ACCESSION NBR: 8211020637 DOC. DATE: 82/10/28 NOTARIZED: NO DOCKET #
 FACIL: 50-397 WPPSS Nuclear Project, Unit 2, Washington Public Power 05000397
 AUTH. NAME AUTHOR AFFILIATION
 BOUCHEY, G.D. Washington Public Power Supply System
 RECIPIENT NAME RECIPIENT AFFILIATION
 SCHWENCER, A. Licensing Branch 2

SUBJECT: Forwards marked-up Section 8.3 to FSAR Amend 23, clarifying
 electrical separation issues, per 821006 meeting. Changes will
 be incorporated into future FSAR amend.

Subject: NUCLEAR PROJECT NO. 2
FINAL SAFETY ANALYSIS REPORT
SECTION 8.3 CORRECTIONS

TABLE 8.3-25

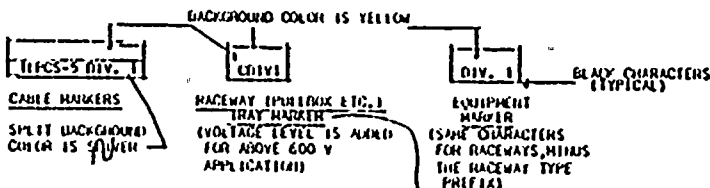
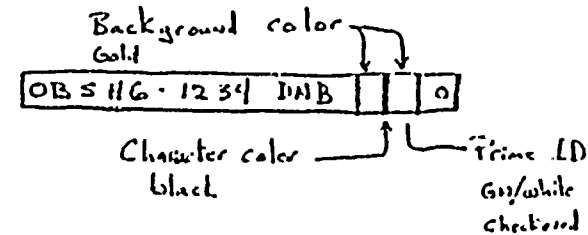
DIVISION MARKERS FOR EQUIPMENT, RACEWAYS, & CABLES EXTERNAL TO PGCC
